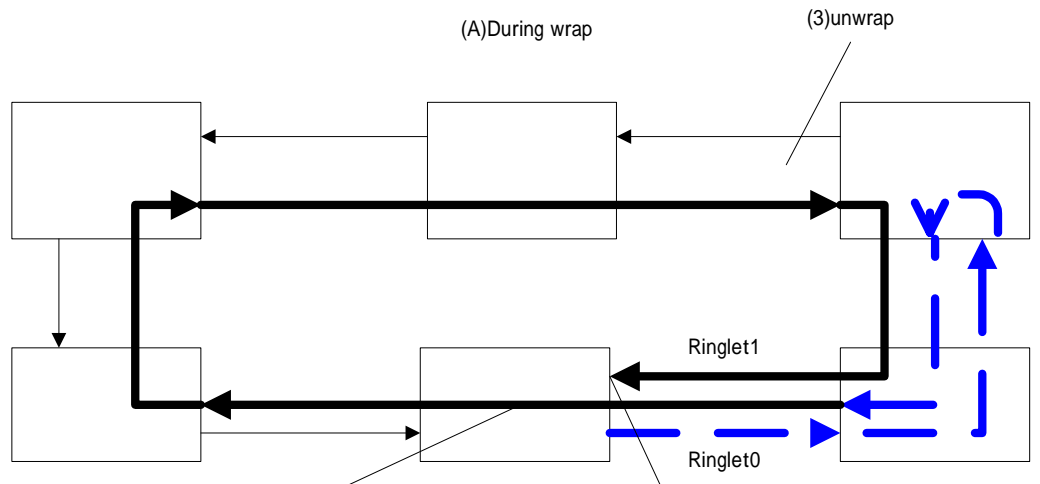
(A) During wrap

(4)frame.ps==0 && RingletID!=frame.ri
&& myMACAddress==frame.sa
then ps=1

(B)unwrap

(5)frame.ps==1 && RingletID!=frame.r
&& myMACAddress==frame.sa
then frame is not discarded?
